Monitoring Year 1 Report
FINAL
Meadow Brook Stream Restoration Project
Yadkin County, North Carolina
Yadkin River Basin, Hydrologic Unit Code (HUC) 03040101

**RE: Response to Draft Task 6 – Year 1 Monitoring Report for the Meadow Brook Site
Yadkin River Basin – CU# 03040101 – Yadkin County, North Carolina
NCDMS Project # 100024, Contract # 007184**

Monitoring Year 1 Report - FINAL

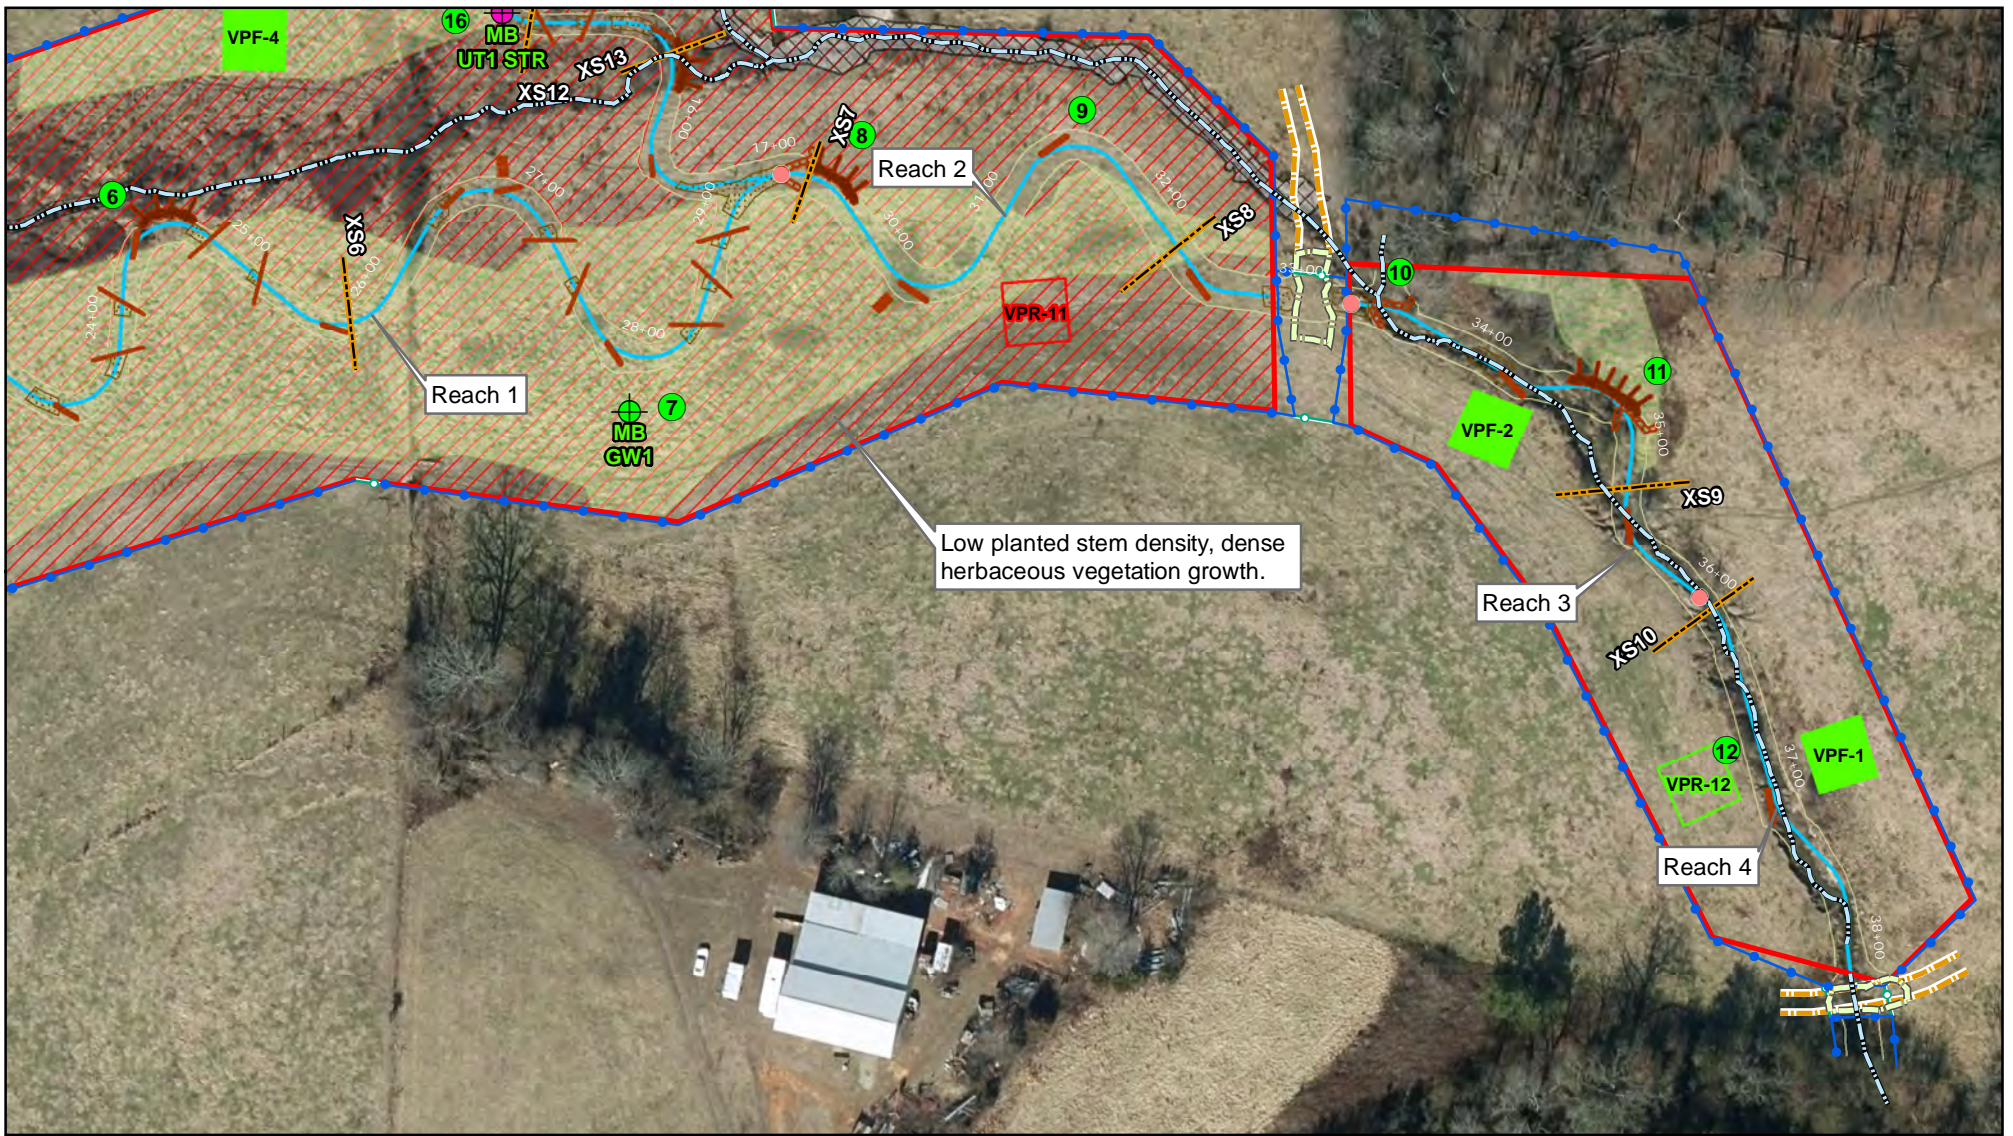
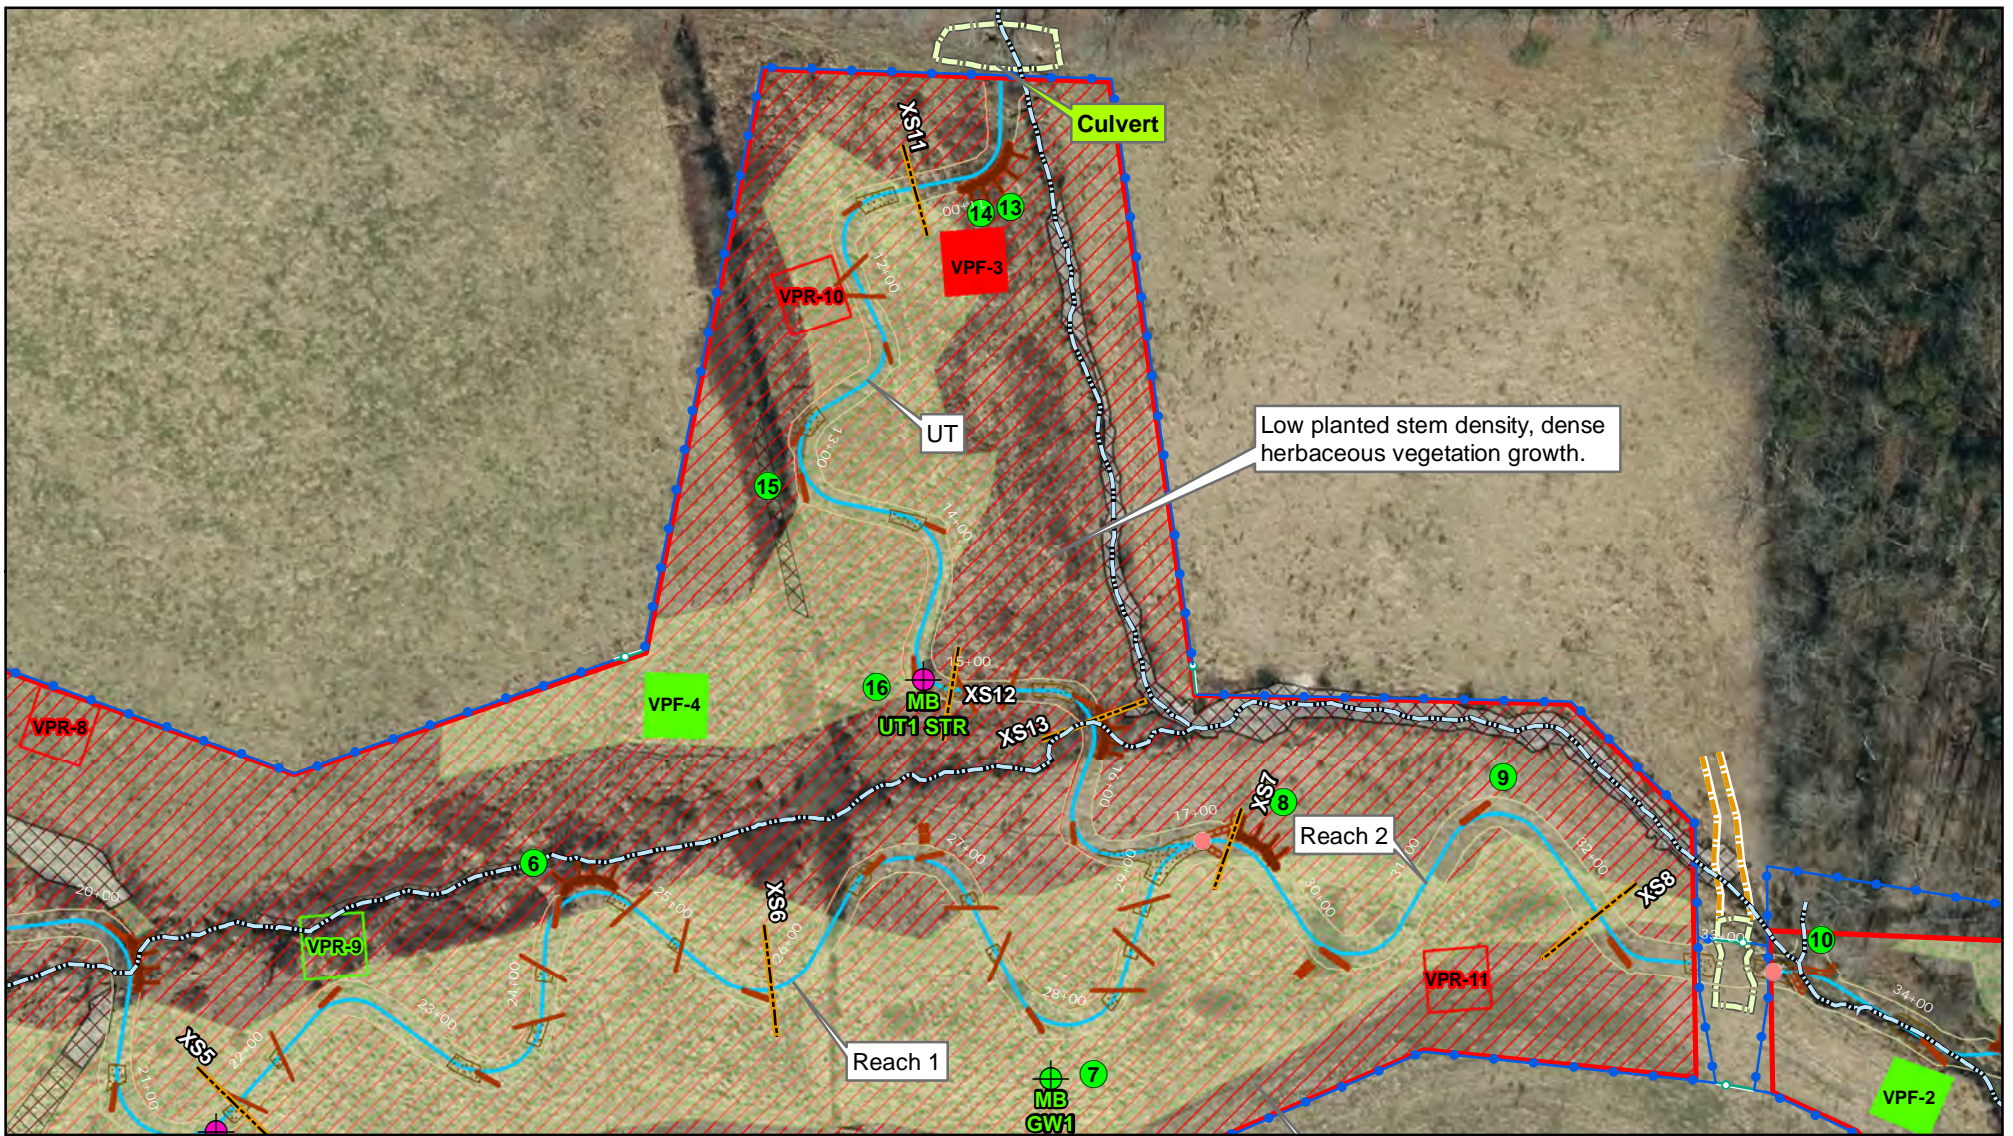
- *As usual EPR's mapping format and content look coherent and accurate, thank you for the quality GIS production. Only comment is that vegetation plots not meeting criteria should be "red" on the CCPV Maps.*
 - **Vegetation plots that did not meet the criteria have been changed to red on the CCPV maps.**
